The 55 details drawn differently in CAD and Revit

Checked against the new drafters' file, 26 October.

55 of the 190 CAD typical details have a Revit version in your templates that is drawn differently. Each page: your CAD detail on the left, the Revit version on the right, what differs, and one answer: CAD is right, Revit is newer (we update CAD from it), or both wrong.

CAD: KOR-D201-DET 01 - TYPICAL DETAIL AT JUNCTION OF 60 TO 36 DEEP RAFT

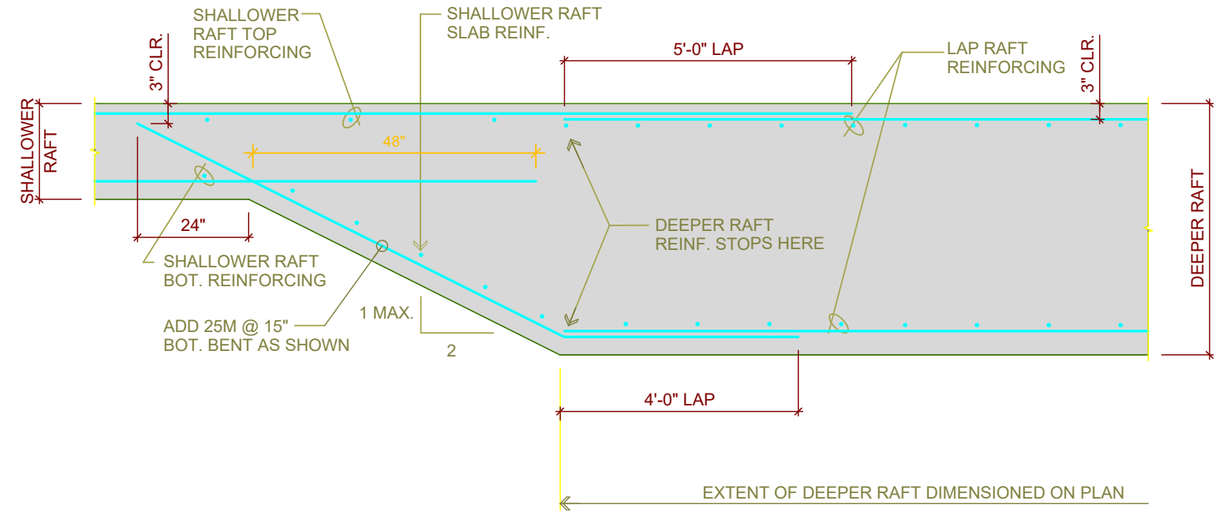
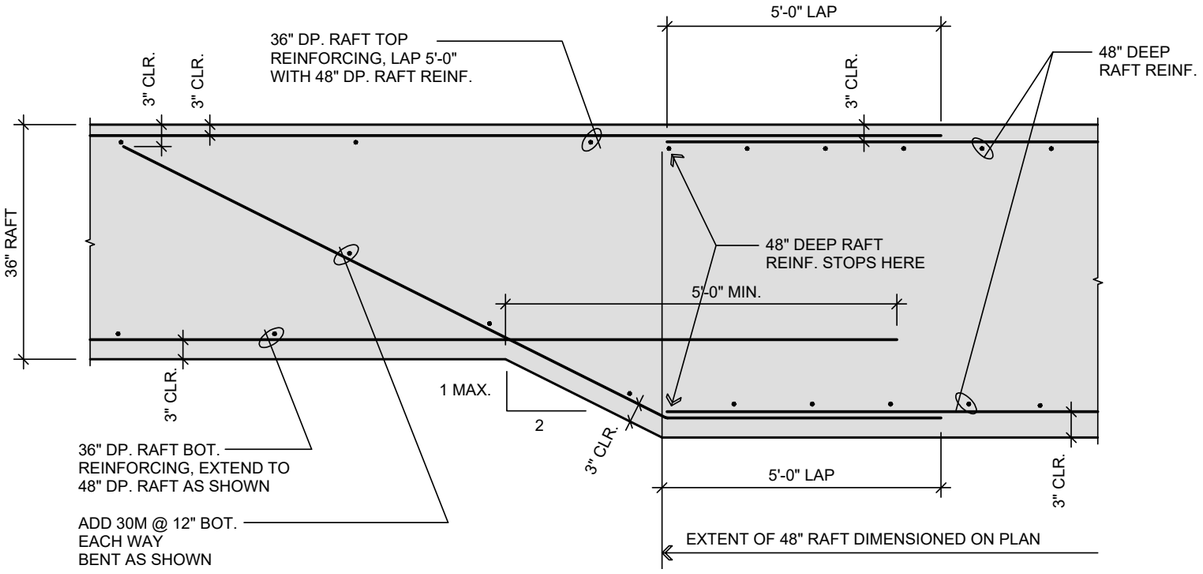
What differs: 60-to-36 junction version: same sloped transition but extra top-bar extension and 60-in raft reinforcing callouts; 'D2.01_1_TYPICAL CHANGE IN RAFT SLAB THICKNESS' is the generic change in thickness.

CAD: KOR-D201-DET 02 - TYPICAL DETAIL AT JUNCTION OF 48 TO 36 DEEP RAFT

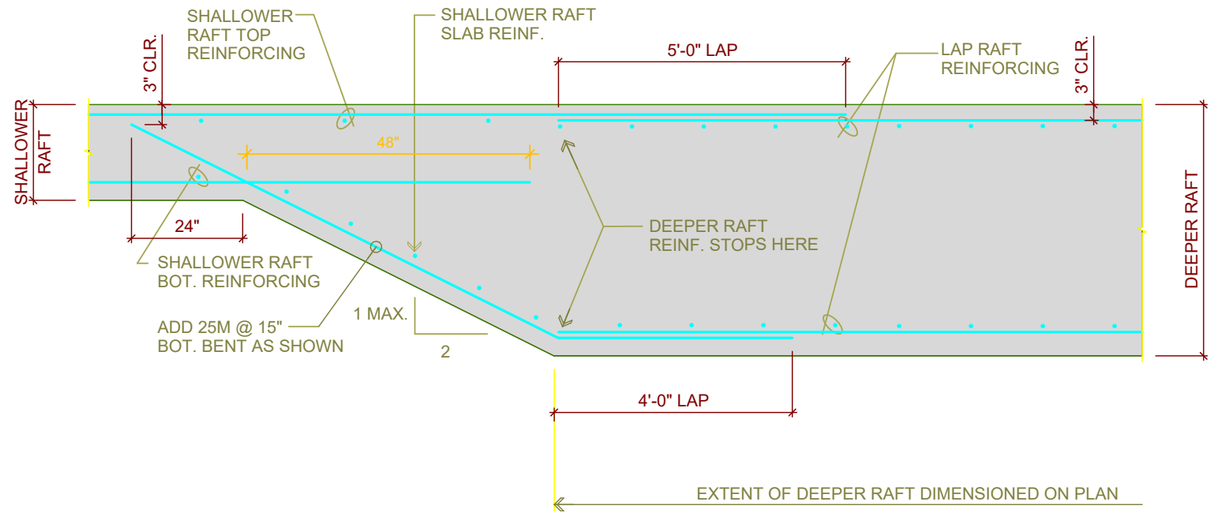
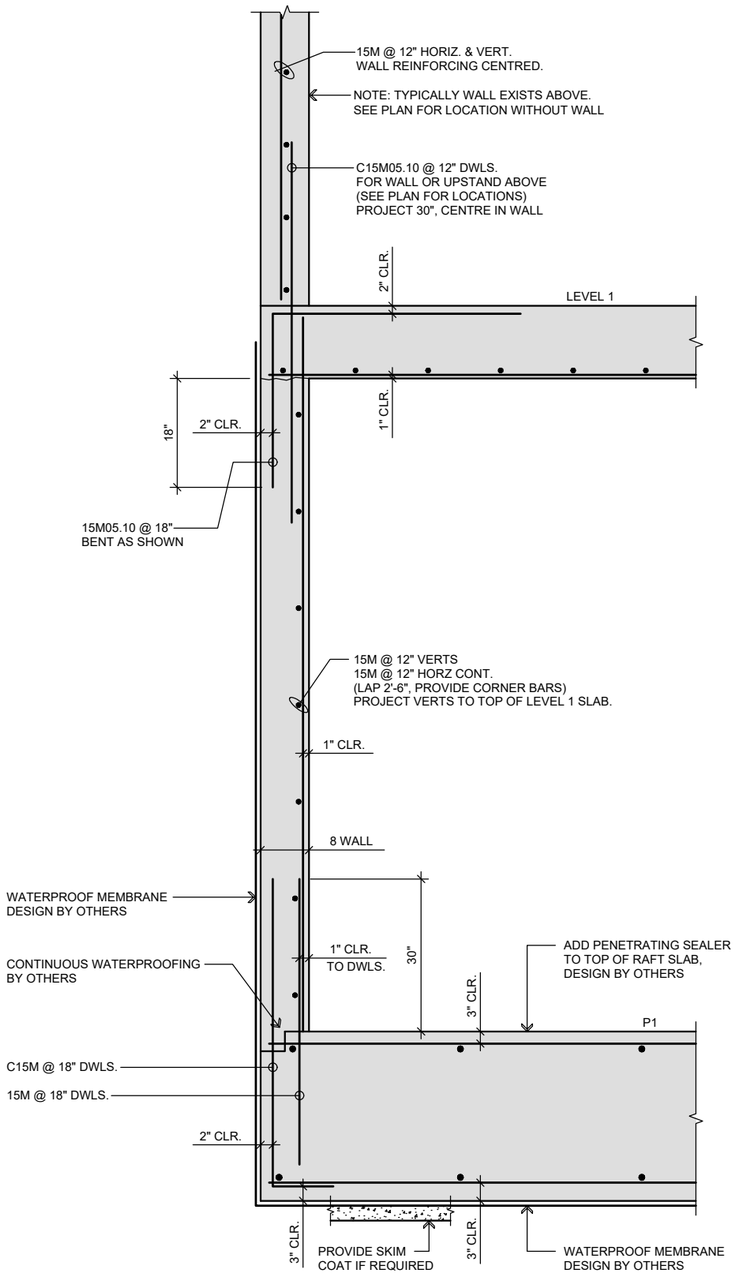
What differs: 48-to-36 junction version of the sloped raft transition; adds 48-in deep reinf callouts and a 30M bent bottom bar vs generic 'D2.01_1_TYPICAL CHANGE IN RAFT SLAB THICKNESS'.

CAD: KOR-D201-DET 03 - TYPICAL BASEMENT WALL

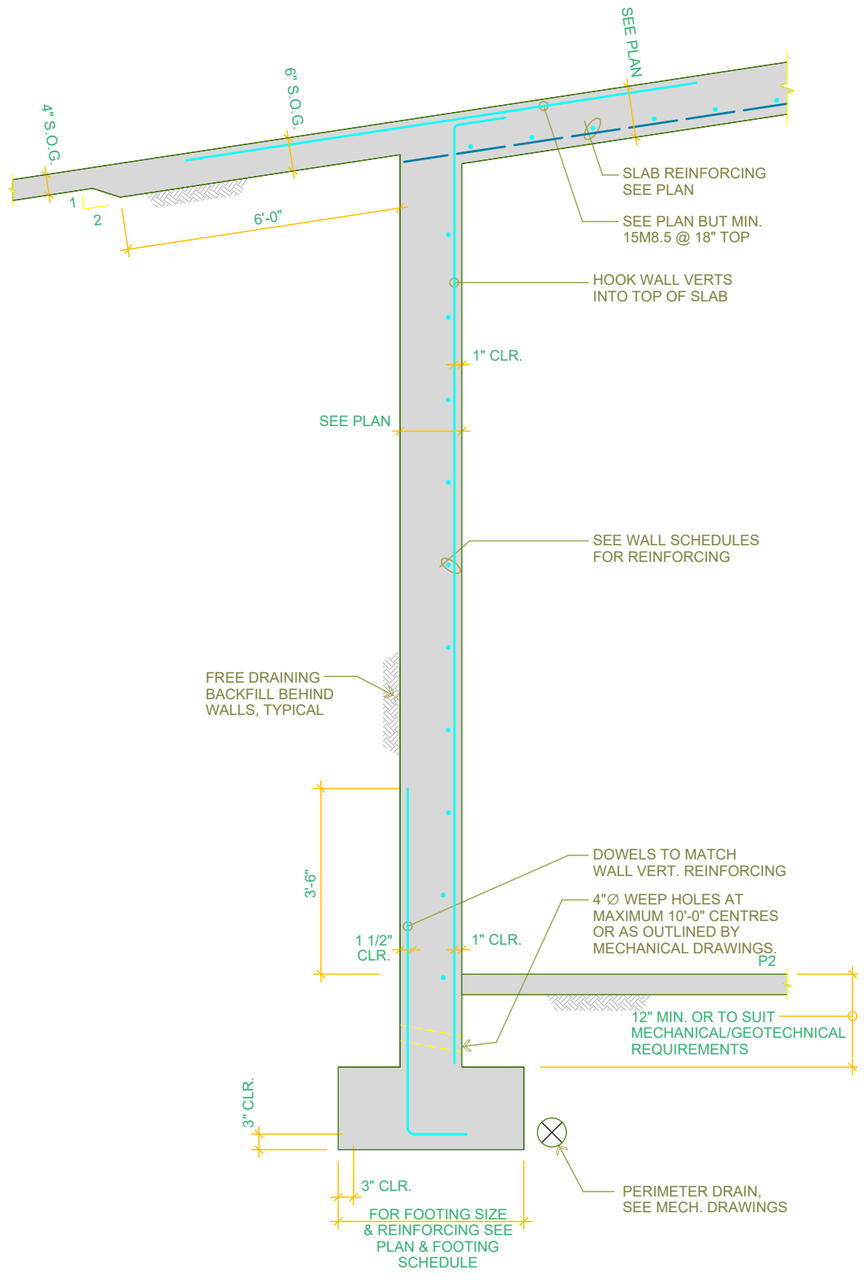
What differs: CAD is a basement wall running from suspended slab down into the raft with an intermediate slab; 'S5.05_1_BASEMENT WALL DETAIL' is a wall with sloped slab over and strip footing.

Revit: D5.01_1_TRENCH DRAIN ON GRADE DETAIL (Typical Details - Container_R23 (Need_MET & IMP).rvt; on D5.01 Series 5 Miscellan)

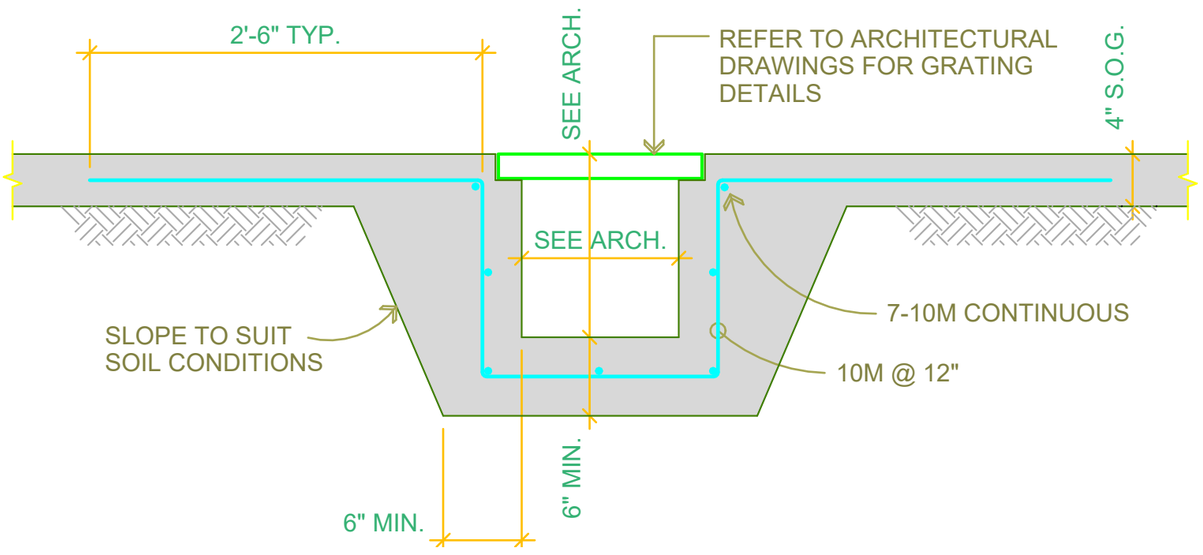
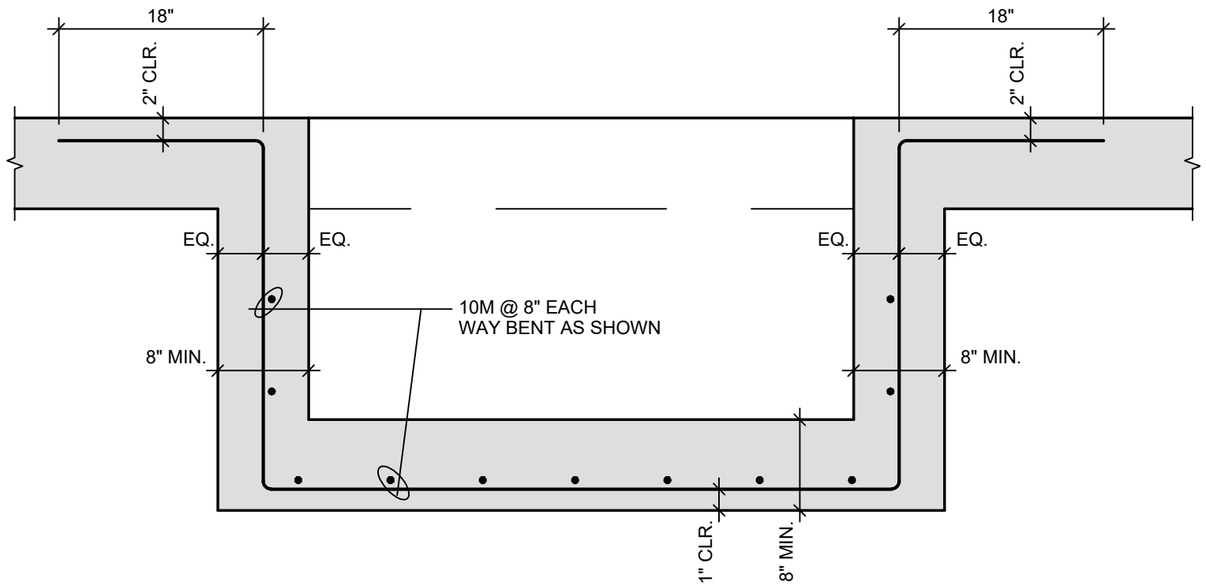
What differs: CAD is a trench drain in a thickened raft with 20M bars; 'D5.01_1_TRENCH DRAIN ON GRADE DETAIL' is the on-grade thickened trench of the same shape but different slab and bars ('D5.01_2_TRENCH DRAIN ON RAFT DETAIL' is a topping-on-raft trench).

CAD: KOR-D201-DET 11 - TYPICAL PIT IN STRUCTURAL SLAB

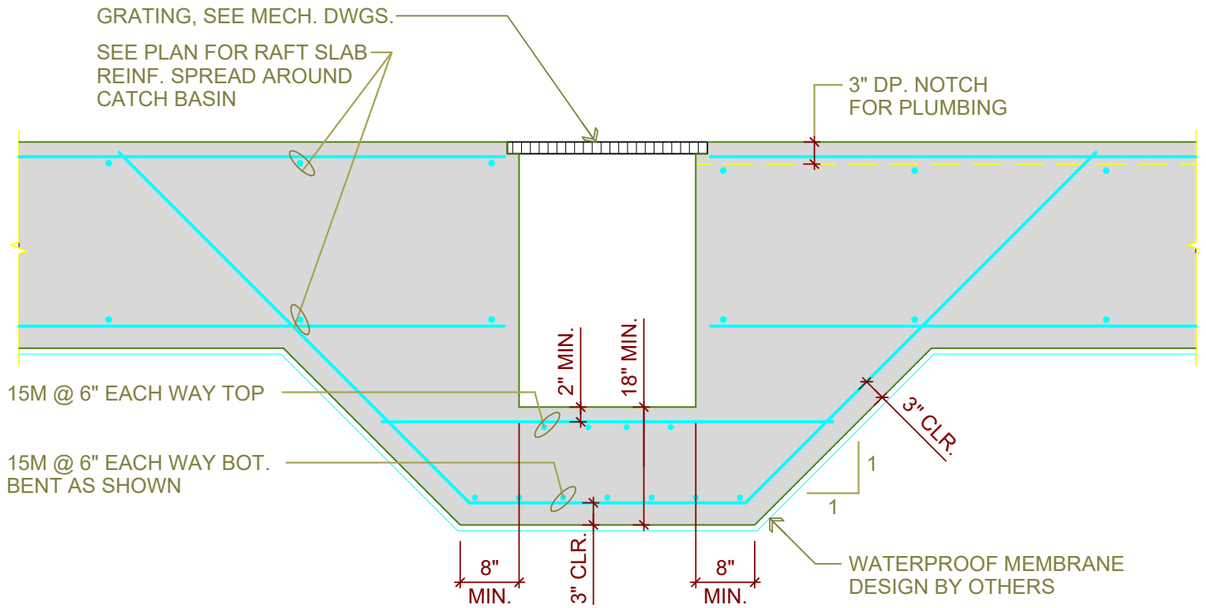
What differs: CAD is a square-sided pit dropped into a structural slab with 10M bent bars; 'D2.01_3_TYPICAL DETAIL AT CATCH BASIN OR SUMP IN RAFT SLAB' is a sloped-sided catch basin sump in raft - same purpose class, different shape and bars.

CAD: KOR-D201-DET 13 - SLOPE BETWEEN SLAB THICKNESS TYPICAL UNO

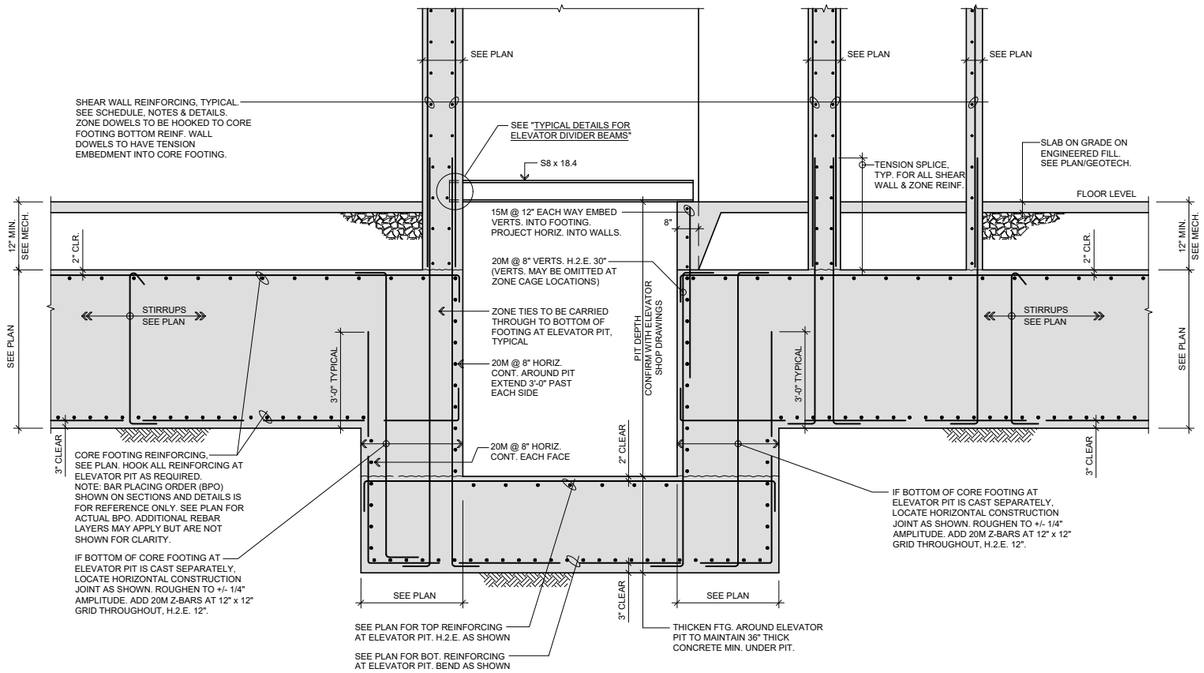
What differs: CAD slope between slab thicknesses has stirrups and tension laps on both layers; 'D2.01_1_TYPICAL CHANGE IN RAFT SLAB THICKNESS' shows a simpler bar arrangement.

7 of 55 CAD: KOR-D202-DET 02 - TYPICAL SECTION THRU CORE FOOTING AT ELEVATOR PIT

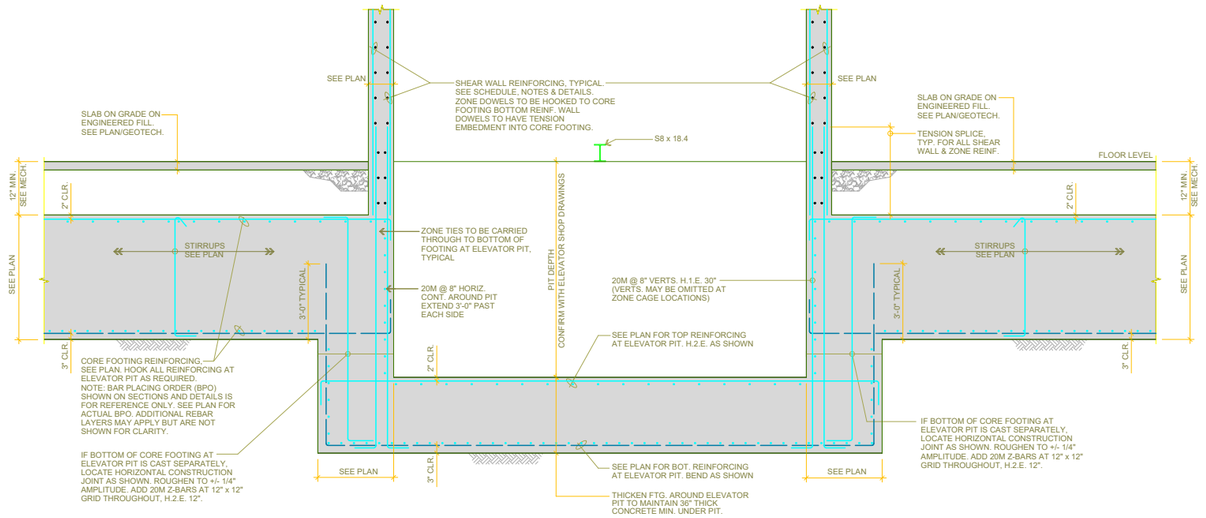
What differs: Core footing at elevator pit with a divider beam and extra horizontal bar callouts not in 'S6.01_2_CORE FOOTING SECTION THRU ELEVATOR PIT'.

CAD: KOR-D202-DET 03 - TYPICAL SECTION THRU CORE FOOTING AT ELEVATOR PIT

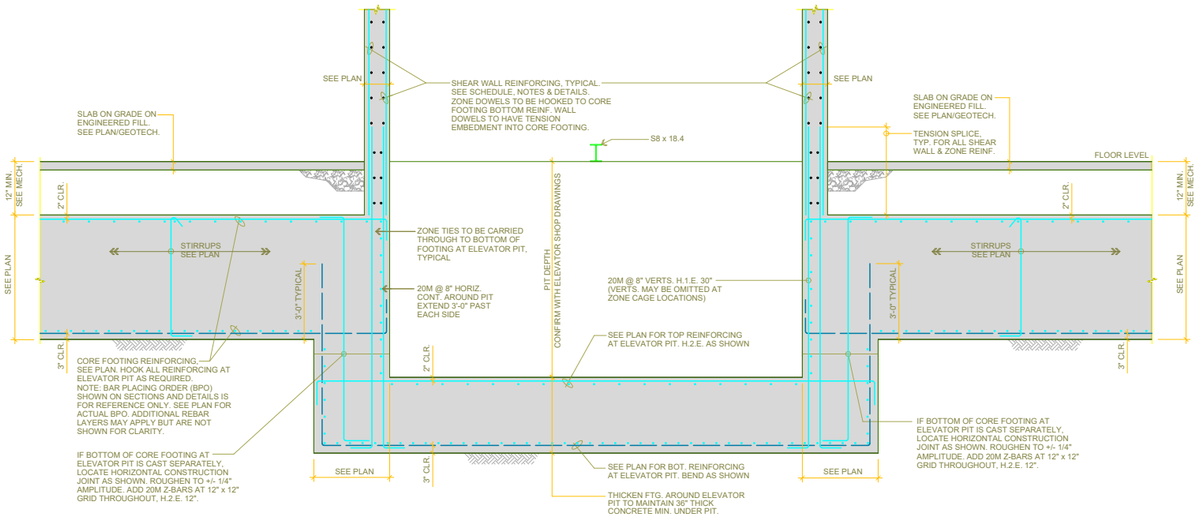
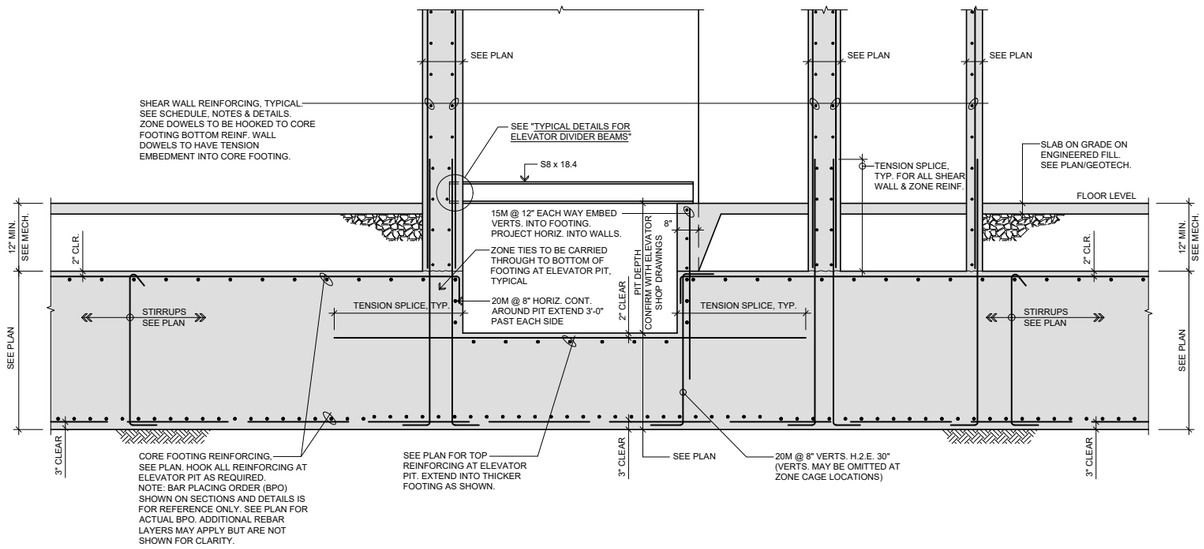
What differs: Core footing at elevator pit variant: flat footing with thicker pit slab, fewer callouts than 'S6.01_2_CORE FOOTING SECTION THRU ELEVATOR PIT'.

CAD: KOR-D202-DET 04 - TYPICAL SECTION THRU CORE FOOTING AT ELEVATOR PIT

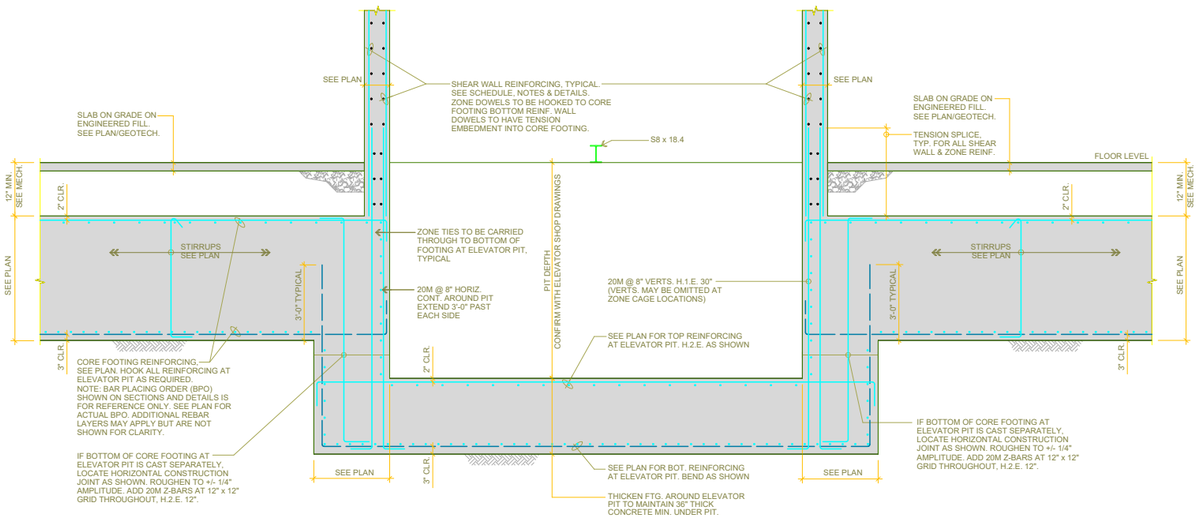
What differs: Core footing at elevator pit variant with an extra divider wall/beam and pit slab arrangement not in 'S6.01_2_CORE FOOTING SECTION THRU ELEVATOR PIT'.

CAD: KOR-D202-DET 07 - TYPICAL SECTION THRU CORE FOOTING AT ELEVATOR PIT

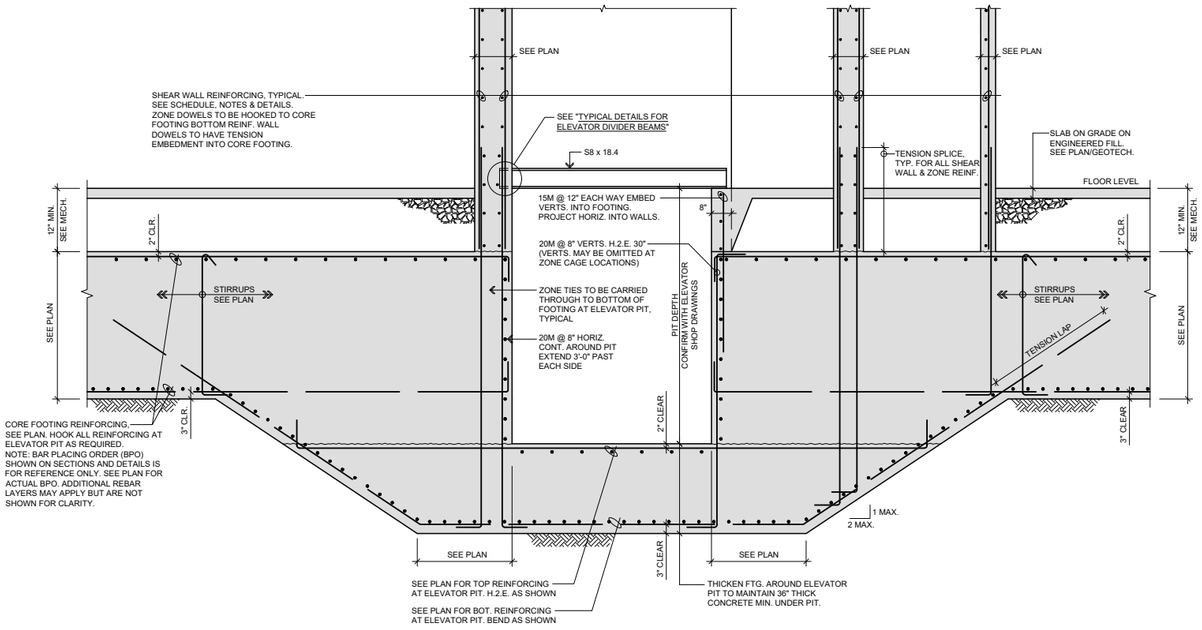
What differs: Core footing with sloped (haunched) sides to the deeper pit; 'S6.01_2_CORE FOOTING SECTION THRU ELEVATOR PIT' has vertical steps.
